2115 EAST JEFFERSON STREET SKETCH PLAN NO. 320220110

No. 320220110

Completed: 12-22-22

MCPB Item No. 6 1-5-2023 Montgomery County Planning Board 2425 Reedie Drive, Floor 14 Wheaton, MD 20902

SCALE: 1" = 30 SHEET NO. SK100

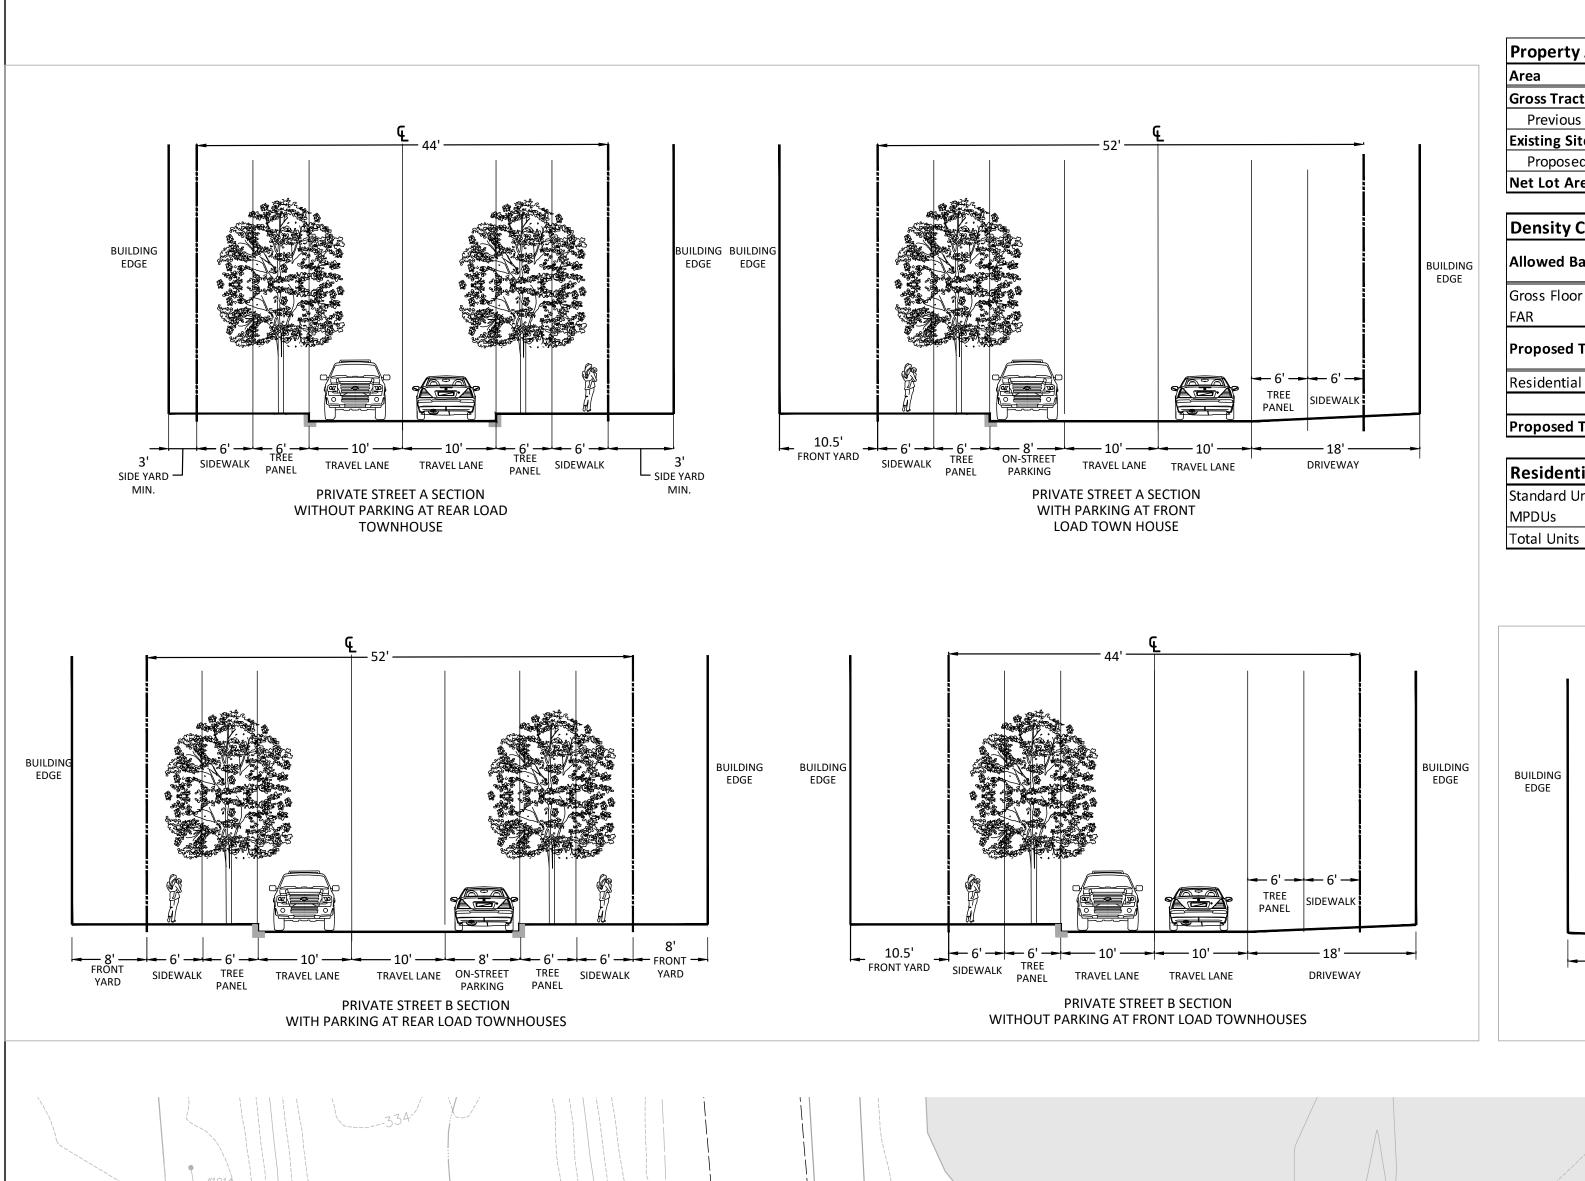
- 1. East Jefferson Street is classified as a Business Street (B-6) with 4 existing lanes and a minimum right-of-way (ROW) of 80-feet. The existing right-of-way on East Jefferson Street per plat #12895 is 80-feet. Note that additional dedication might be needed to incorporate the separated bikeway and sidewalk.

- 2. At the Preliminary Plan stage provide a roadway cross section showing the existing configuration and proposed configuration with the sidewalk and separated bikeway per the Bicycle Master Plan.
